Masterplan Access Design Assessment Report

ST ALOYSIUS COLLEGE  
47 UPPER PITT STREET  
KIRIBILLI NSW 2061

Project: St. Aloysius College, 47 Upper Pitt Street and 1-5 Jeffreys Street, Kirribilli NSW 2061  
 Document Type: Masterplan Access Design Assessment Report  
 Report Number: P217\_312-2 (ACCESS) LD

Figure 03 – Existing Principal Pedestrian Entry Location

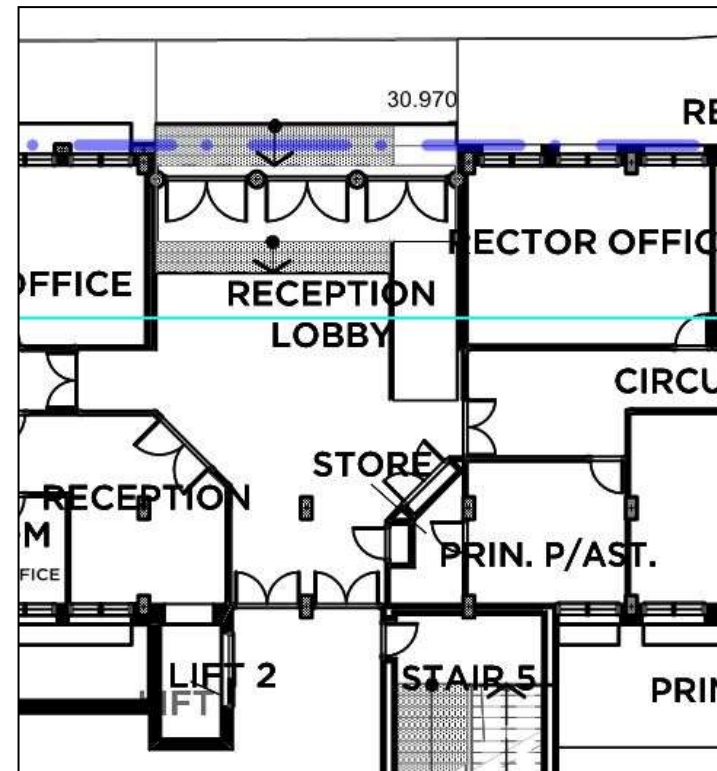
The existing principal pedestrian entrance is located on level 01 to the north, facing Upper Pitt Street. Level access is provided via two (2) non-compliant ramps, with an approximate gradient of 1:10. A new Principal Pedestrian Entrance is proposed in this location and will be designed with a series of ramps and doorways in accordance with the requirements of AS1428.1-2009.

Figure 05 – New / Proposed Principal Pedestrian Entry

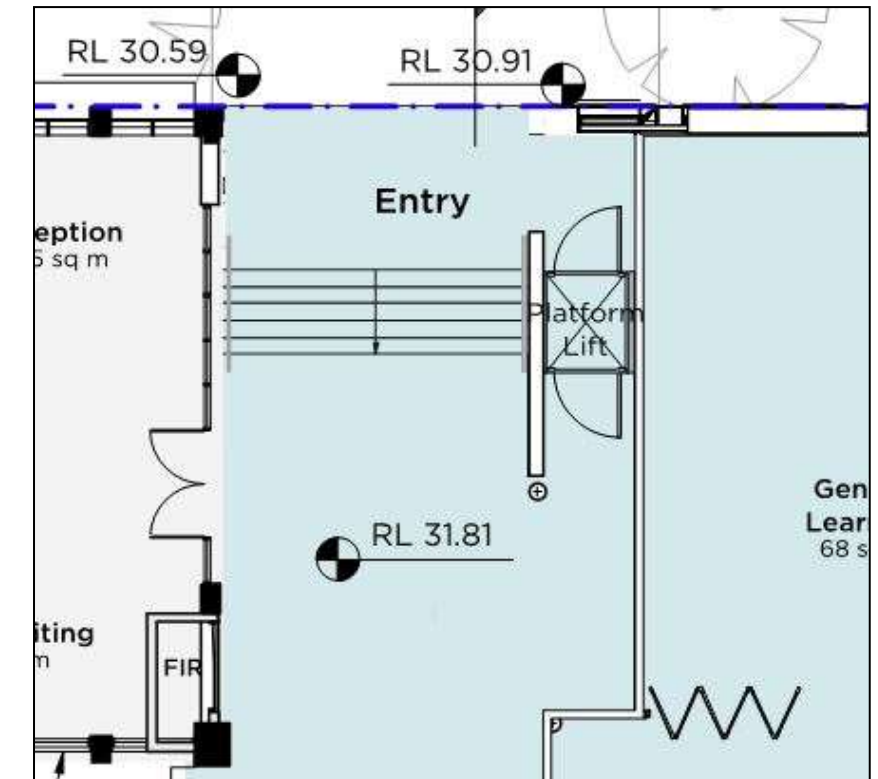
Upgrade works are proposed to replace the non-compliant 1:10 ramp with a platform lift designed in accordance with BCA Clause E3.6 and AS1735.12-1999.

Figure 06 – Existing Wyalla Entrance

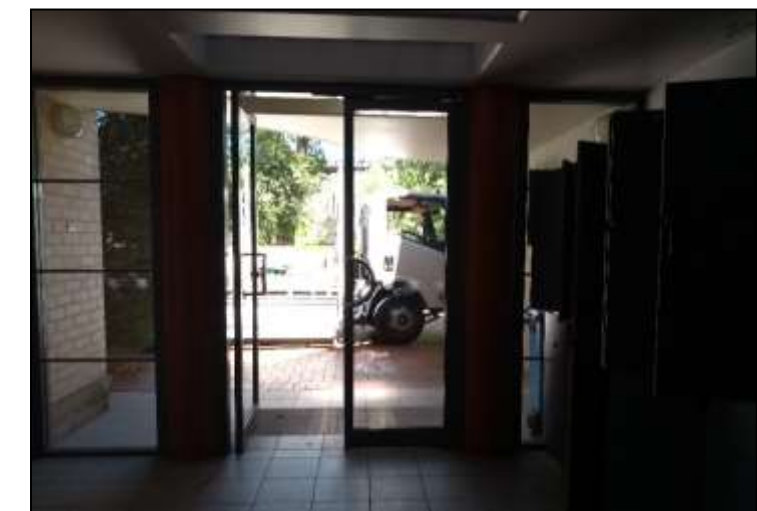
The existing entrance to the Wyalla building is to the west and faces Jeffreys Street. Two (2) sets of doors are

provided, two (2) revolving doors and two (2) swing doors each leaf providing a clear opening width of approximately 650mm. It is proposed that new doors to the main entrance of The Wyalla Building are provided as part of upgrade works. These are to have a minimum clear opening width of 850mm in accordance with the requirements of AS1428.1-2009. It should be noted that for security purposes visitors to the school access the Wyalla Building through the Upper Pitt Street campus via a bridge at level 02.

**Figure 07** – Wylla Ground Floor accessible areas

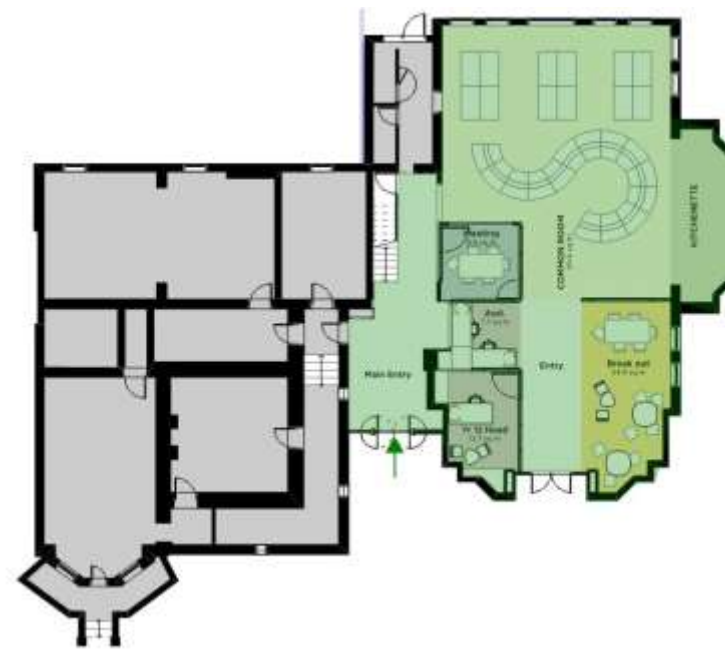
Achieving compliant accessways within Wylla will present a challenge, due to the heritage nature of the building and series of stepped level changes within floors.

Alternative accessways will need to be identified and / or mapped. This approach will be in conjunction with the Heritage Consultants recommendations and will be subject to an access management plan that provides new students and staff with information on how to independently access all new areas of the school in an equitable manner, as required by the BCA.

There will be some areas of the Wylla building (primarily levels 01 and 02) that cannot be accessed by wheelchair users. It will be important to identify a strategy, whereby comparable facilities are offered in an accessible location. **Figures 07-11** illustrate areas where level access can be provided (green) and areas where steps will prohibit access for wheelchair users (red).

**Figure 09** – Upper Pitt Street Campus Proposed Scope of Work

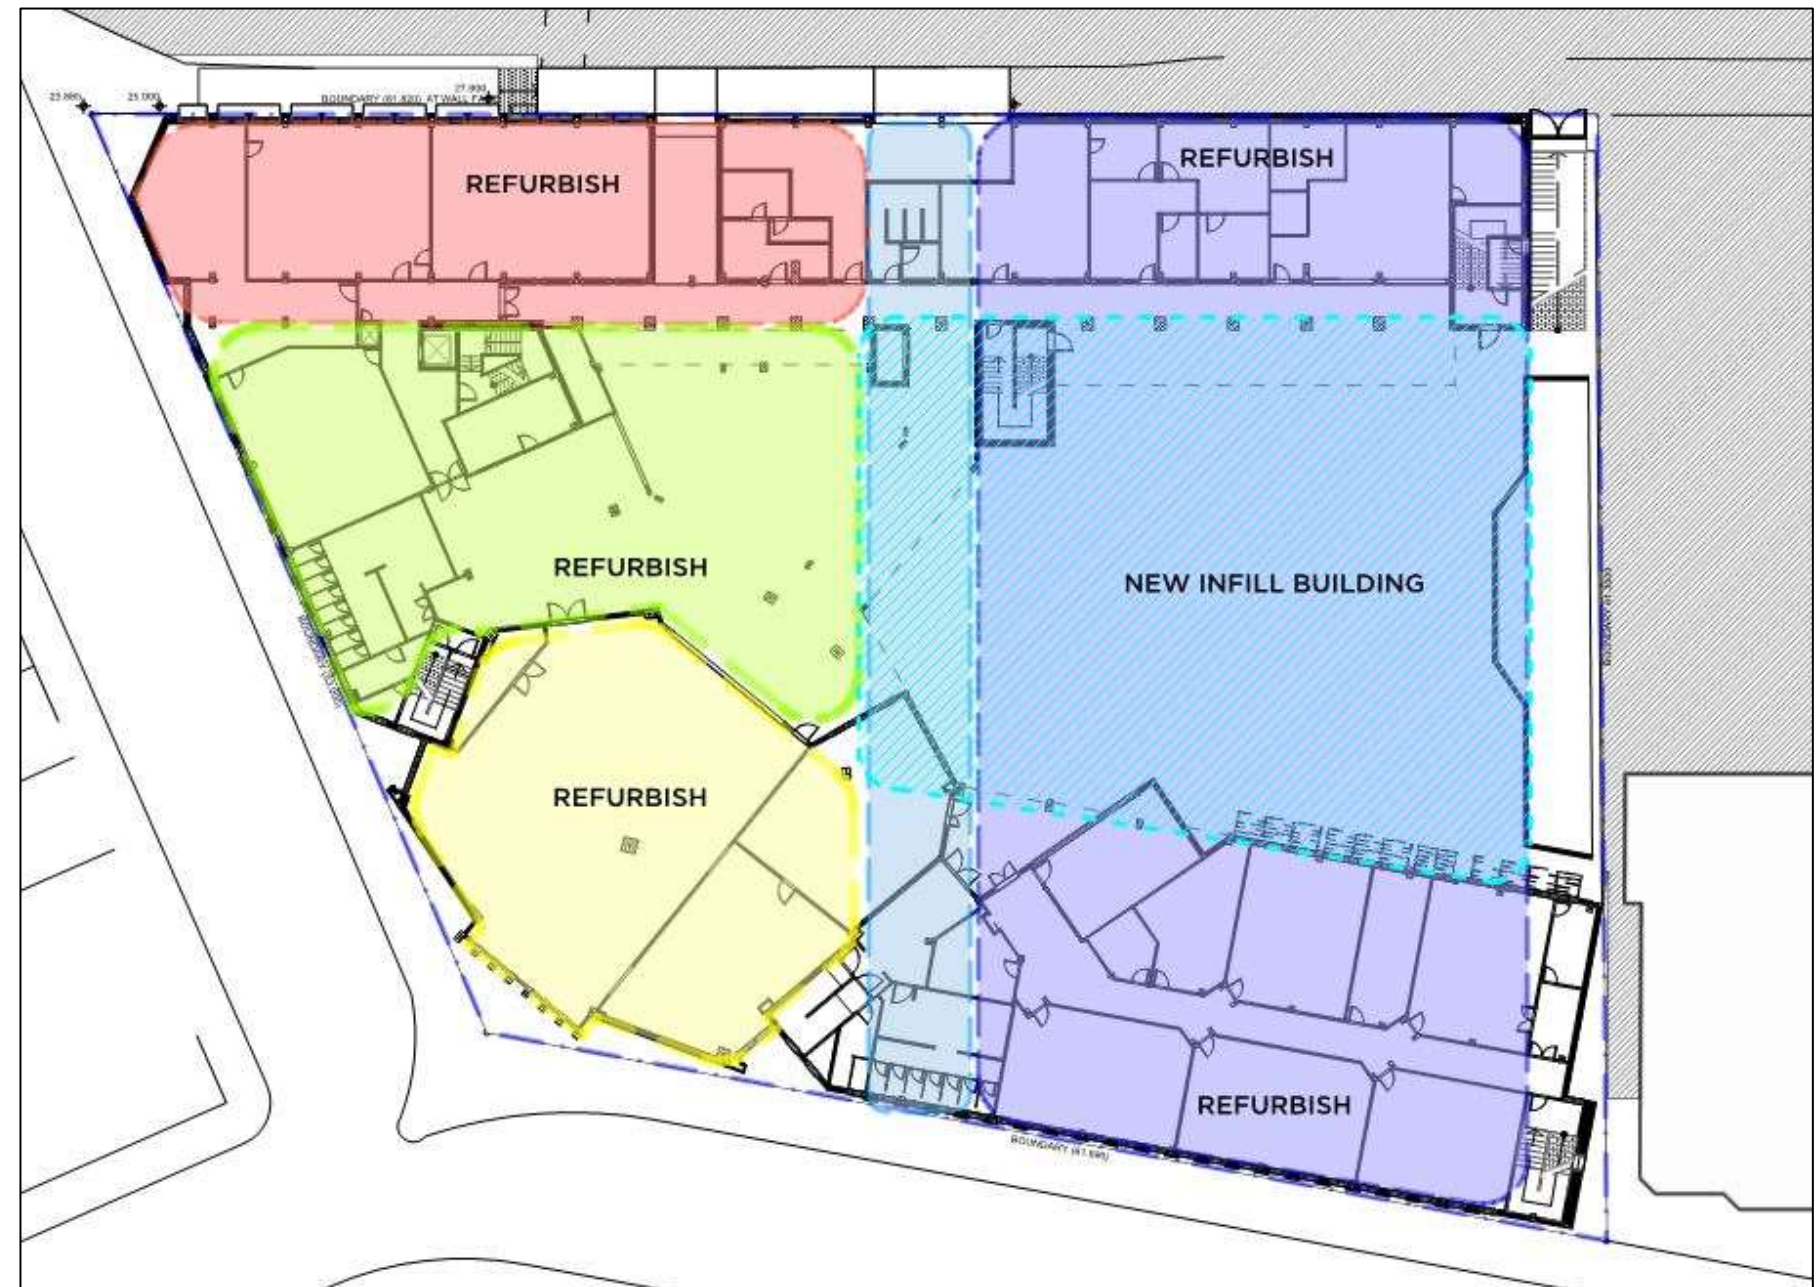
- (i) Ensure where new doorways are proposed, they achieve a minimum clear opening width of 850mm and circulation spaces in accordance with AS1428.1-2009. Where double doors are provided ensure at least one door leaf in compliant;
- (i) Ensure the affected part (continuous accessible path from principal pedestrian entrance) is step – free and in accordance with the requirements of AS1428.1-2009; and

Figure 10 – Wyalla Level 01 Proposed Scope of Work

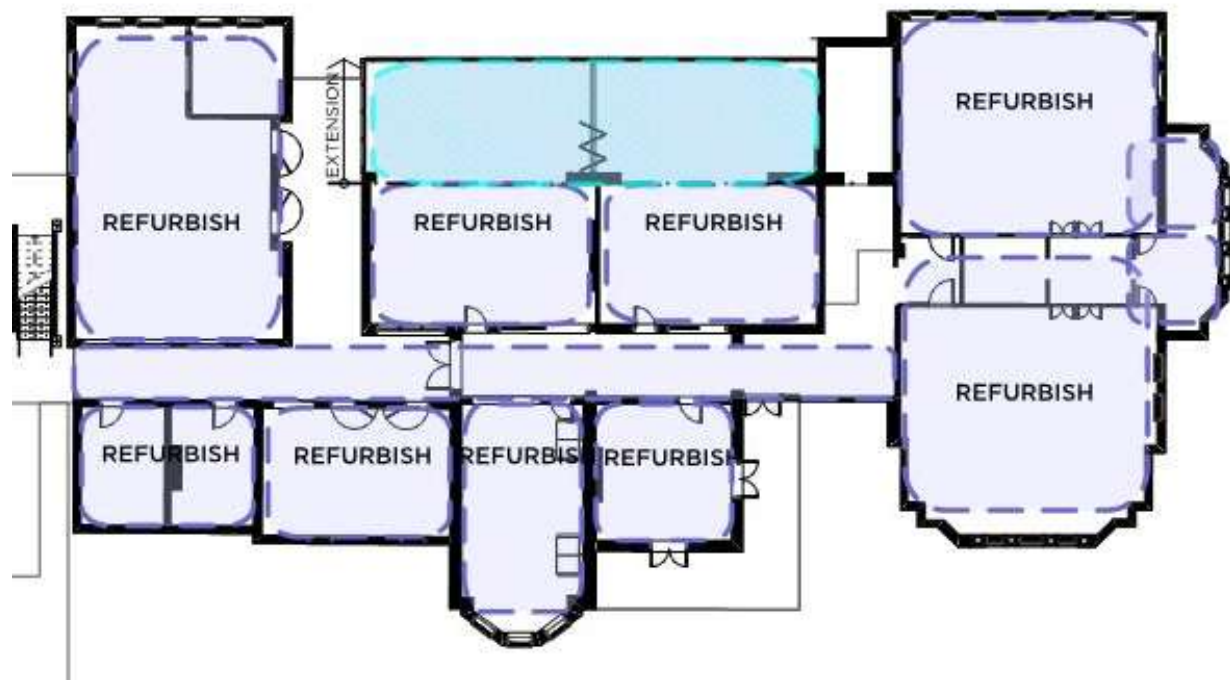
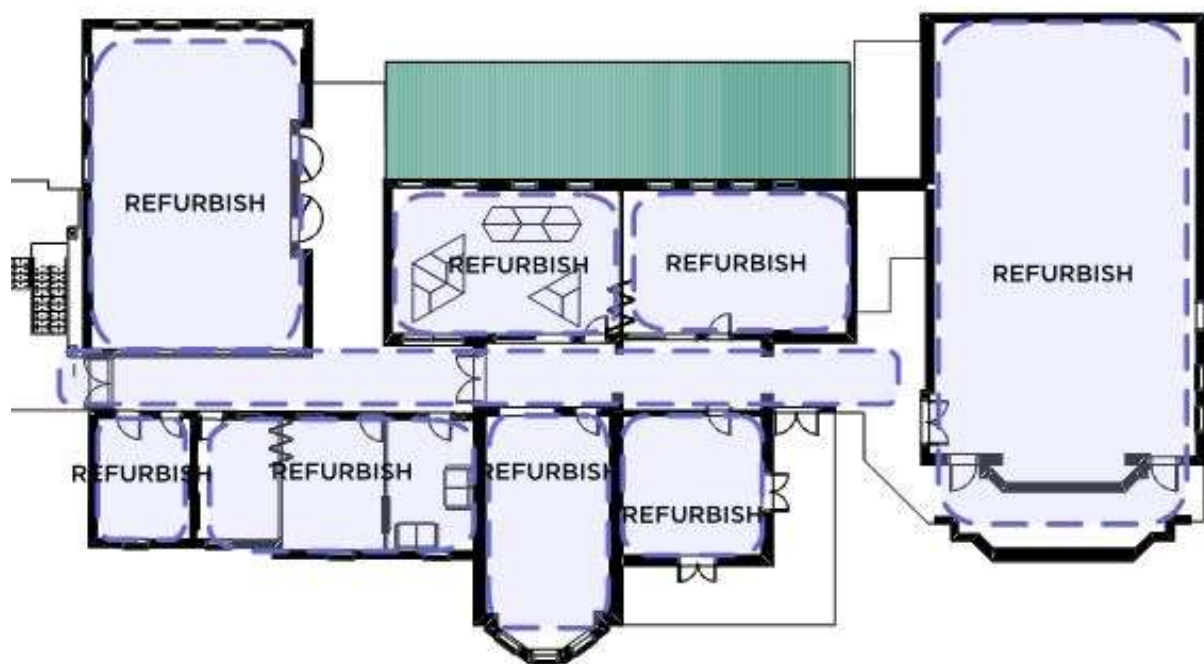
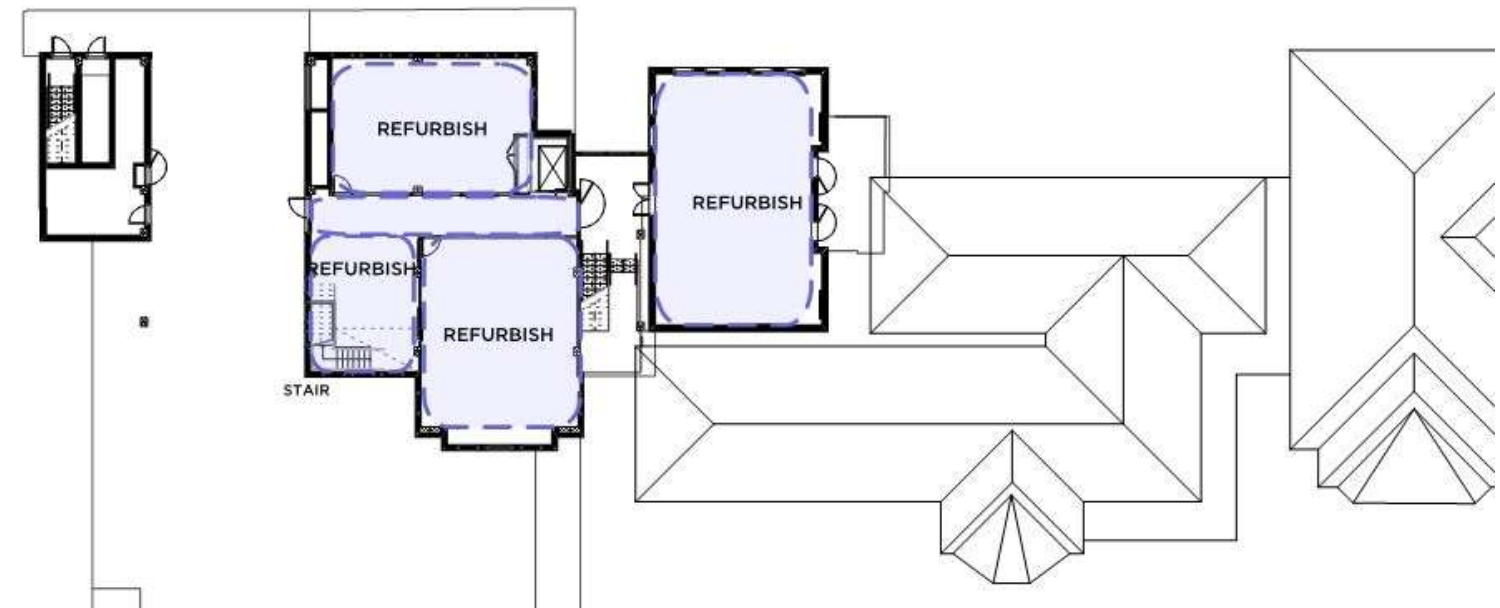
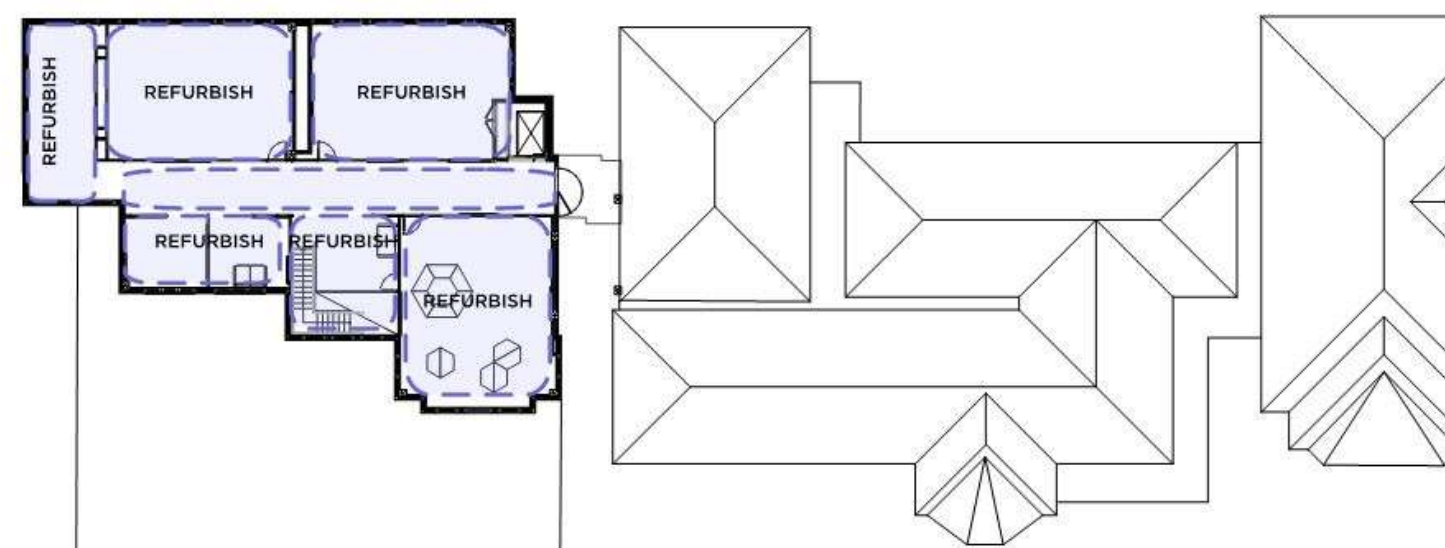
- (i) Ensure all new doorways have a clear opening width and circulation space in accordance with AS1428.1-2009;
- (i) At design detail an Access Management Plan is to be developed to provide a strategy for areas with comparable facilities to those areas which cannot be reached by a wheelchair user, in consultation with Heritage Consultant;
- (ii) Consider upgrading bridge entrance and connection at level 02 to ensure the accessway between buildings is as accessible as possible, and that wheelchair users can safely reach level 02.
